**DETAILED ACTION*****Election/Restrictions***

***Drawings***

The drawings are objected to for the following:

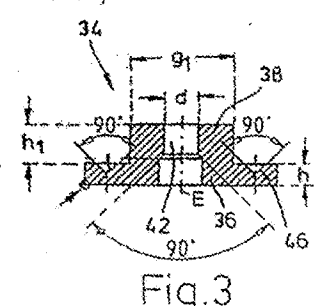
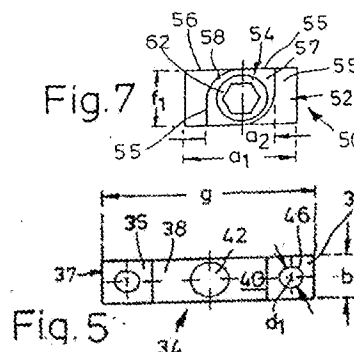
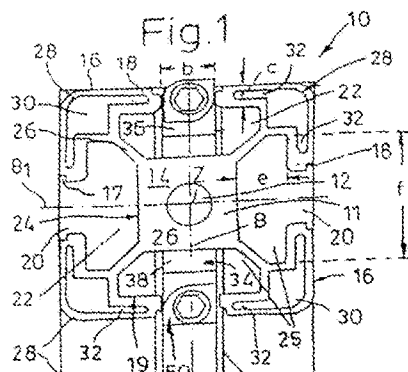
- Figure 1 is not complete since shows only a partial incomplete view of element 50 (upper 50 and lower 50 of figure 1 are not complete). Note that portion 52 (belonging to 50 as seen in figure 7) is not present in figure 1. Further note the lower element 50 as seen in figure 1 does not completely show the entire perimeter of portion 57 as seen in figure 7. Lastly note that figure 1 fails to show a border line between 36 and 52. See figures 1 and 3-7 below too compare.

Corrected drawing sheets in compliance with 37 CFR 1.84 and 37 CFR 1.121(d) are required in reply to the Office action to avoid abandonment of the application. Applicant is advised to employ the services of a competent patent draftsman outside the Office, as the U.S. Patent and Trademark Office no longer prepares new drawings. Any amended replacement-drawing sheet should include all of the figures appearing on the immediate prior version of the sheet, even if only one figure is being amended. The figure or figure number of an amended drawing should not be labeled as “amended.” If a drawing figure is to be canceled, the appropriate figure must be removed from the replacement sheet, and where necessary, the remaining figures must be renumbered and appropriate changes made to the brief description of the several views of the drawings for consistency. Additional replacement sheets may be necessary to show the renumbering of the remaining figures. The replacement sheet(s) should be labeled “Replacement Sheet” in the page header (as per 37 CFR 1.84(c)) so as not to obstruct any portion of the drawing figures. If the changes are not accepted by the examiner, the applicant will be notified and informed of any required corrective action in the next Office action. The objection to the drawings will not be held in abeyance.
